# Agenda Report

**TO:** Honorable Mayor and City Council  
**FROM:** Planning & Community Development Department  
**SUBJECT: PREDEVELOPMENT PLAN REVIEW OF A MIXED-USE PROJECT  
LOCATED AT 245 SOUTH LOS ROBLES AVENUE**

Site Plan:

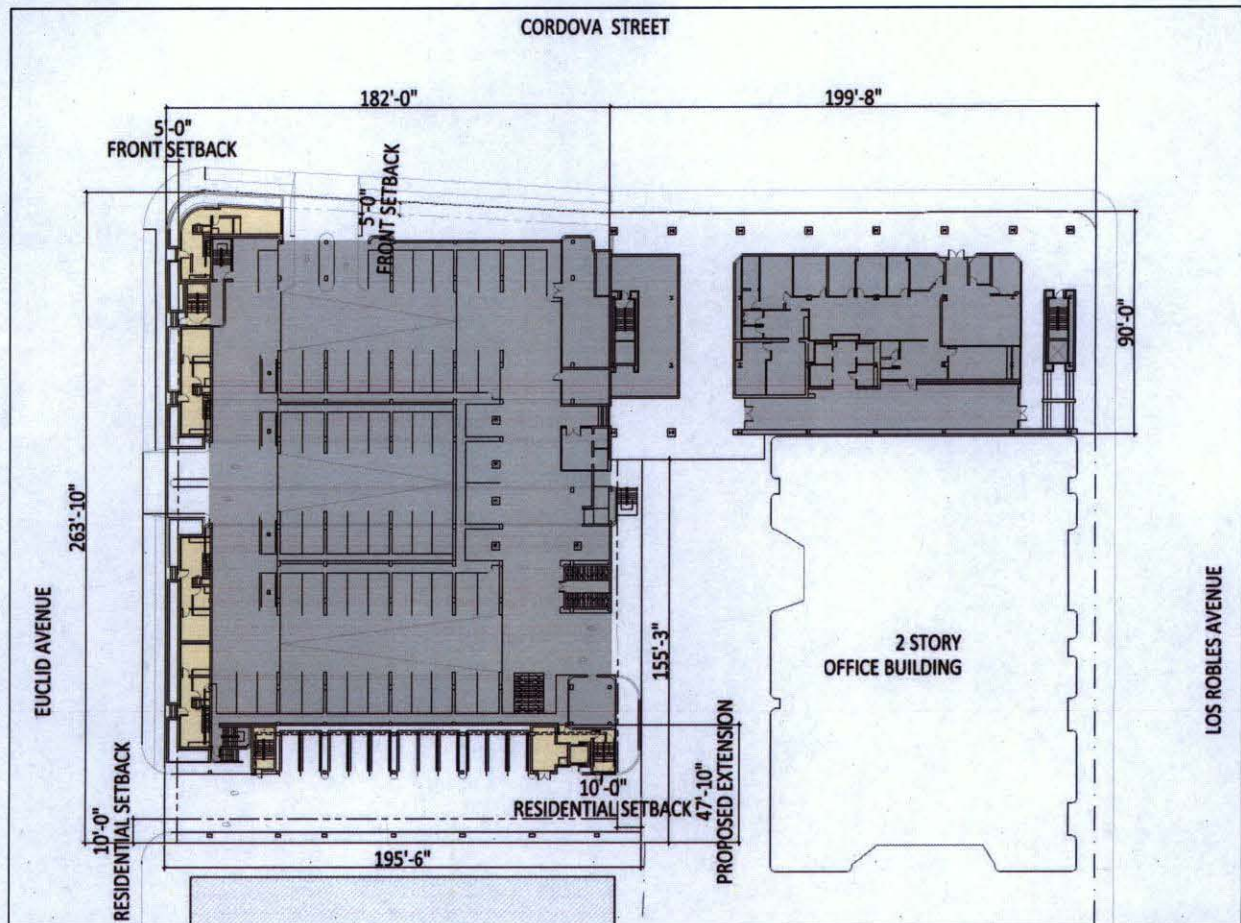
The plans indicate that three rooftop penthouse additions are proposed. These additions exceed the base height requirement and would require a Variance. The applicant has indicated that these additions would be removed from future submittals in order to avoid a Variance.

The proposed improvements on this portion of the site would have a height of approximately 68 feet and exceeds the maximum height requirement. Because the project is proposing to utilize the Density Bonus provisions pursuant to Chapter 17.43 of the Zoning Code, the project may be eligible to apply for an Affordable Housing Concession Permit to exceed the height development standard. Section 17.43.050 of the Zoning Code outlines the application requirements, procedure, and findings for an Affordable Housing Concession Permit.

Based on the submitted information, this portion of the site measures 18,564 square feet and therefore is afforded a maximum FAR of 41,769 square feet. The existing building on this portion of the site has a floor area of 114,954 square feet, or an FAR of 6.19, and is deemed nonconforming as it exceeds the allowable FAR. The project proposes to add additional floor area on the roof level by constructing rooftop additions for three penthouses, increasing the FAR to 6.25. The proposed additions would add additional floor area beyond what is permitted and would require a Variance. The applicant has indicated that the project would be revised to remove these additions and avoid the need of a Variance on future submittals.

The proposed plans indicate that 33 units are provided that measure less than 650 square feet and 98 units measure more than 650 square feet. As a result, the project is required to provide a minimum of 193 parking spaces and a maximum of 218.

At this time it is not clear which parking standard will be utilized and thus compliance cannot be verified. The applicant would identify the utilized parking standard on future submittals.

The submitted plans did not provide information as to the amount of administrative office and retail use that would be proposed, thus compliance cannot be verified. The applicant would identify the amount of commercial uses proposed on future submittals

Based on the plans submitted is not clear whether the project meets the open space requirement as described above as the. Full dimensions will be required on all future submittals to demonstrate compliance with the open space requirements.
